**CITY OF ISSAQUAH**  
**Development Services Department**  
**DEVELOPMENT COMMISSION**

**STAFF REPORT**

**Project No.** PRJ12-00009  
Application No. SDP13-00005 (Site Development Permit)  
Application No. SHO13-00014 (Shoreline Substantial Development Permit)

Project name: CADENCE (a.k.a. Seventh At Gilman, Gilman Square)

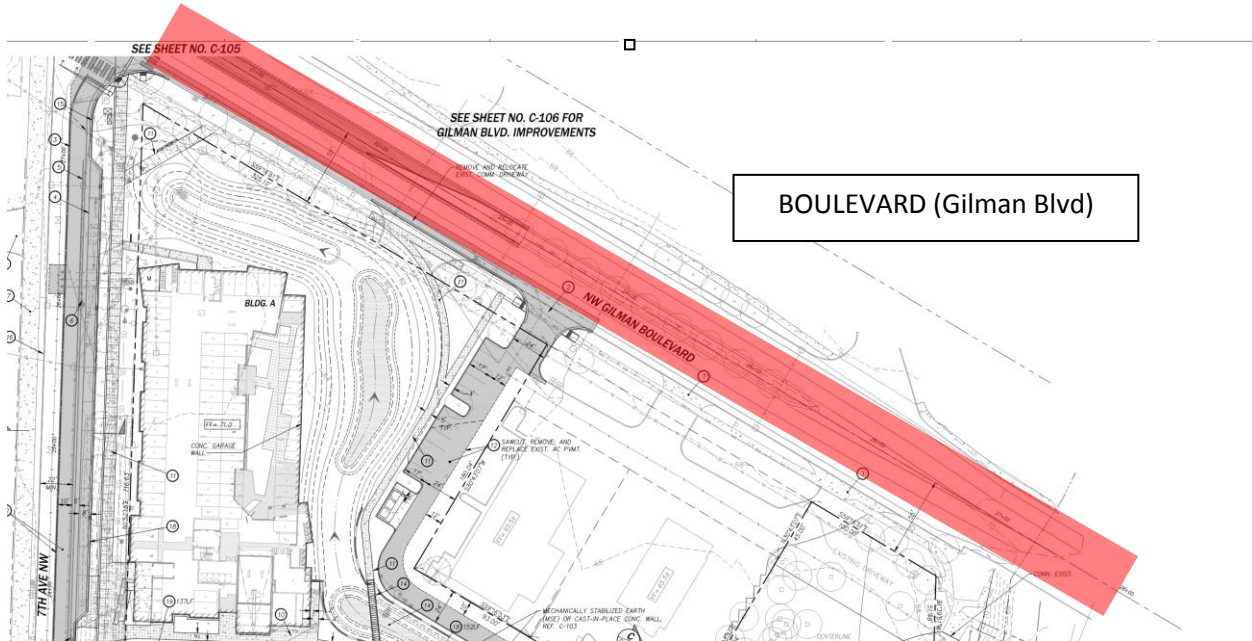
The current design of Gilman Boulevard does not meet some elements of the Circulation Facilities standard. Street curbing along the length of the site will need to be shifted approximately 1 foot southward in order to accommodate the 27 feet width required for two

11 foot wide travel lanes and for one 5 foot wide bike lane. The plan will also need to provide the 6 foot wide planting strip and the 6 foot wide sidewalk. The eastern side of the site is more limited in frontage improvements as an existing driveway onto Gilman Boulevard from the KFC/Taco Bell site crosses over the Cadence site as allowed by easement. This eastern portion of the site may be a location in which a fee in lieu of actually constructing improvements is appropriate. [Condition #5] The City may consider fee in-lieu for the western improvements facing Gilman Blvd but it will be at the City's discretion.

Possible location for year - round covered park element:  
South of fenced dog run and east of Shared Use Route.

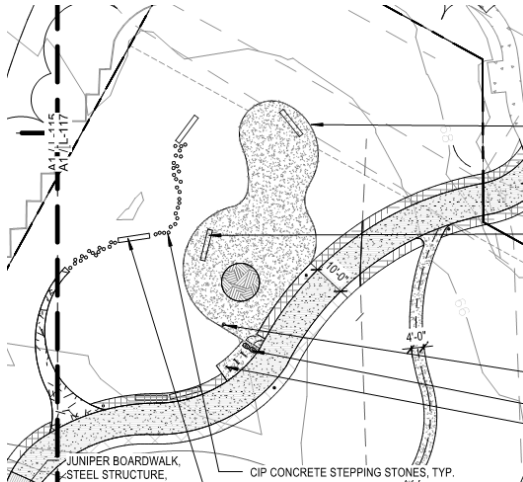
A portion of that park will be included with this project, west of Issaquah Creek. A clear visible connection to the Green Necklace (Issaquah Creek) is required and provided. Neighborhood Parks need to include design elements integrating pedestrian connections, visual and recreation variety to engage all age groups, have features that are usable year-round (such as pergola, gazebo, and pavilion). The proposal generally meets the requirements of the Significant Community Space; however, covered features are not proposed within the park area of Cadence partly because building are not allowed within 115 of Issaquah Creek (creek buffer & setback), although there could be an opportunity for such features on the edge just outside of the creek buffer and setback as shown below. **[Condition #7]**

That space has been shown on plans as “Park and Open Space” and is meadow lawn and can be used for passive recreation. The park space will include a fenced dog run just west of the Shared Use Route including a pet waste station, benches, bicycle racks, and trash receptacles. (see diagram below of schematic design and location). See Construction Conditions.

- 7 With the submittal of permits to construct the park area, provide an element to meet the year round use requirements of Chapter 7, such as a gazebo or weather protection.

Fenced Dog Run,  
west of Shared Use  
Route

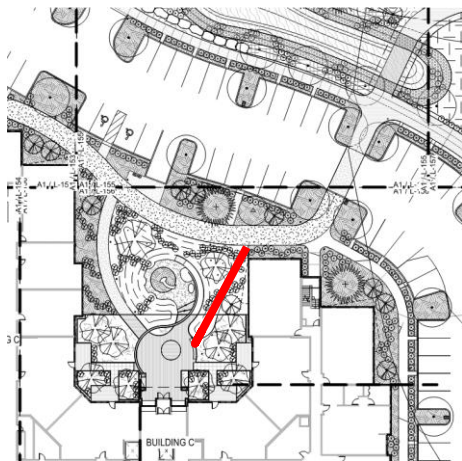
The remaining area of this park area is passive open space landscaped in lawn and can be used more actively for ball games or Frisbee. Per Chapter 7.5, the applicant will be able to receive a credit against the value of the land for significant community space that is set aside in lieu of full mitigation of Parks and Recreation Impact fee. The value of the park for credit and for the Shared Use Route will need to be calculated before Building Permits are issued.

Extended easterly walkway  
connection recommended within  
Courtyard C to Shared Use Route.

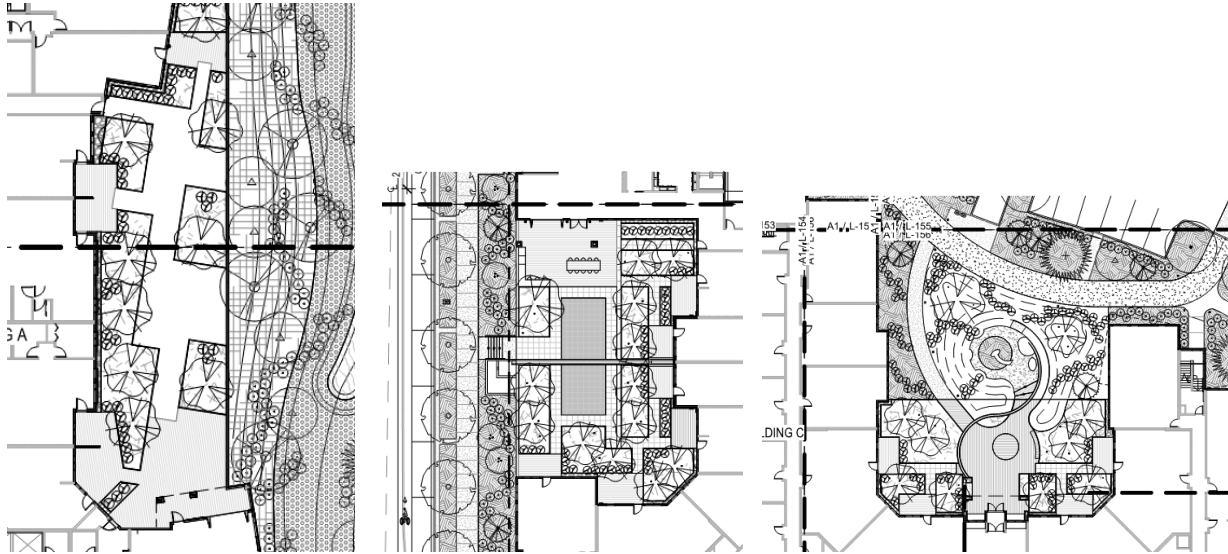
Note that a P-patch garden described with the project narrative is no longer part of the community space plan. A nearby P-patch is located within Confluence Park to the south.

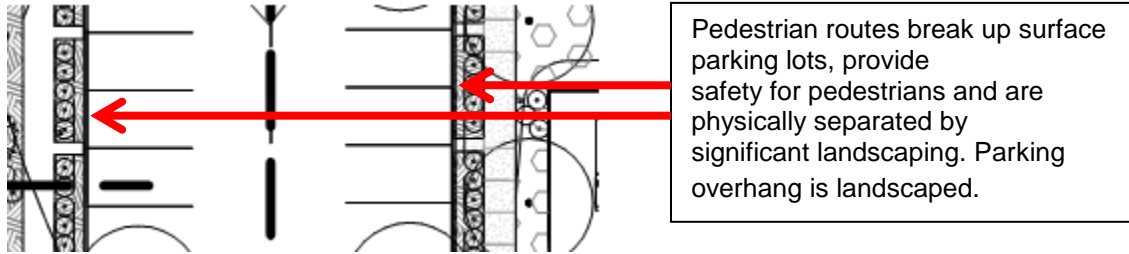
Up to 60% of the parking stalls may be designed as compact stalls and up to 5% of the total stalls may be designed as Micro stalls. The project proposes the parking stalls designed as follows:

- 147 Standard sized stalls 36.75%
- 248 Compact sized stalls: 62.00%
- 5 Micro sized stalls: 1.25%

The project is over the code allowed maximum for compact stalls by 2% (8 parking stalls). Parking for the project will need to be designed to comply with the 60% maximum allowance. **[Condition #10]**

#### Parking Lot:

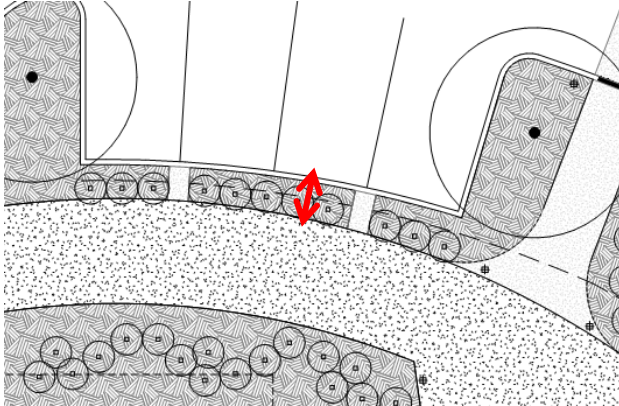
The chapter requires that parking lots provide one tree for every six stall and provide edge landscaping. Edge landscaping is landscaping that has a minimum width of 3 feet or substituted with fencing or a wall that is at least 75% opaque. Plants need to achieve 3 feet height at maturity and 2 feet high at installation.

The small lot west of O'Reilly Auto complies as there are 11 parking stalls there (plus the dumpster enclosure area), 2 trees are required, and 4 are provided in peninsula islands. That lot also has the required edge landscaping between the stalls and a walkway. The lot also requires 10% interior landscaping. The lot is approximately 6,800 sq. ft. requiring 680 sq. ft. of interior landscaping. 690 sq. ft. is provided plus the edge landscaping.

The larger meandering parking lot also requires 1 tree for every 6 parking stalls and that lot has 93 stalls (including loading spaces). 16 trees are required and 22 trees are shown in peninsulas/islands. The lot is approximately 35,600 sq. ft. requiring 3,560 sq. ft. of landscaping and approximately 4,250 sq. ft. is being provided. The preliminary plan has ornamental dogwood trees in both the smaller and larger parking lots and a broader canopy type tree is required by the Parking Design Standards (15.4.E). Smaller ornamental trees such as the Centennial Tree, Eddies White Wonder Dogwood would be better suited in courtyards as a single specimen or in small group plantings, per Chapter 10.17. See Construction Conditions.

On the north side of the lot with an overhang of 18", 4 ½' of landscaping is required for the 18" overhang plus the 3 feet of edge landscaping. In some areas the planter width because of the meander with the parking lot and Shared Use Route is shown at 4 feet and will need to be slightly widened. (see drawing below) Where insufficient space is available for the landscaping width, a screening wall may be substituted.

Where the parking lot is adjacent to the Shared Use Route, the landscape width needs to be 6 ½ feet in width (2' for the Shared Use Route, plus 3' with parking lot edge landscaping, plus 1 ½ feet for parking overhang). Not all of the required landscaping width between the stalls and the Share Use Route appears to meet the standard and will need to be corrected with the final construction plans [**Condition #14**].

2' of landscaping required by Shared Use Route, 3' of landscaped buffer required with parking lot, plus parking overhang is to be landscaped. Some low screening walls may be needed where the planting width is insufficient.

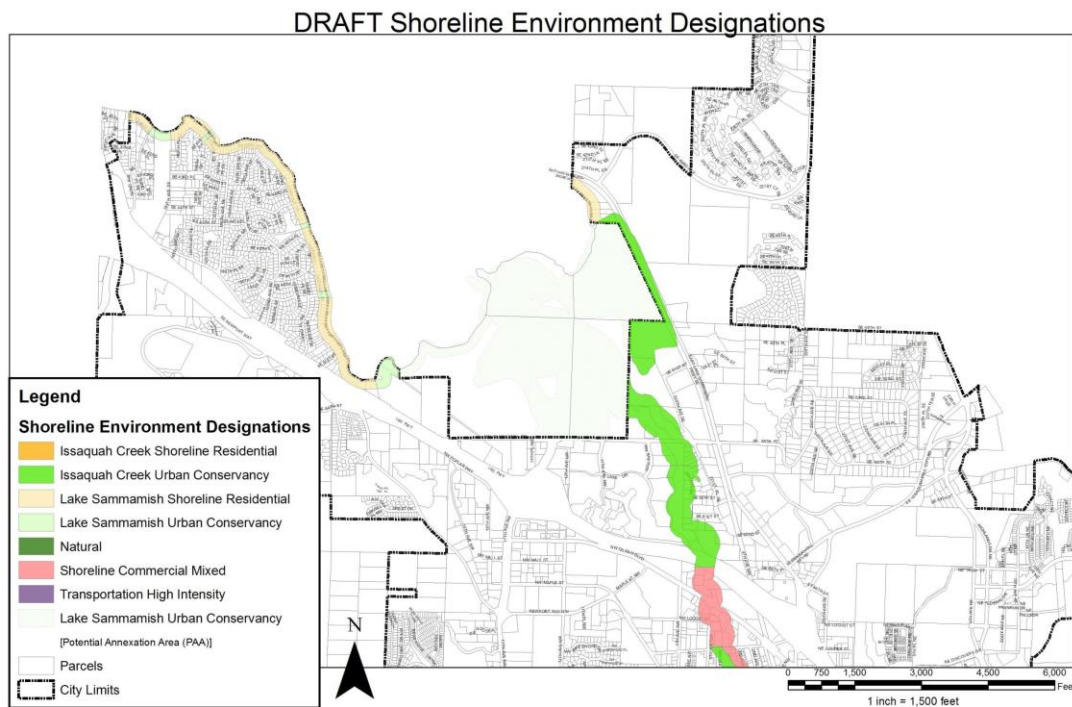
Chapter 17 provides the standards for lighting. Lighting that has been selected for the project includes a hierarchy of selected to ensure a safe, attractive environment for users after dark. The locations of the lights are shown on the enlarged landscaping plans, including light poles that will be mounted 15 feet in height (the maximum allowed), and staggered along 7<sup>th</sup> Avenue

lights on planters and stairs, and bollards at changes in walk direction. The lighting fixtures proposed will need to be confirmed with a photometric plan that they are sized appropriately for activities without overlapping illumination patterns. Crossing vehicle lanes will provide lighting at a pedestrian scale. The pedestrian bridges will have low level of light on the bridge decks to guide users across. Catenary lights are shown in a festive string design between Buildings B & C. Those lights should be designed to reflect downward to maintain dark sky. [In some paved areas plazas, LED solar paver lights will be incorporated. No lighting will be proposed in the open space Critical Area adjacent to Issaquah Creek. All lighting fixtures will need to be specified to comply with BUG ratings.

The actual designs of light fixtures were not provided with the SDP application but some photo examples are shown on the colored landscape detail sheet. The enlarged landscaping plans list in a legend and plans identify by location, the various types of lights proposed, including street light poles, bollard lighting, recessed lights, LED solar power lights, catenary lights, and uplights. Details of these various types of fixtures will need to be provided for review with the construction permits.
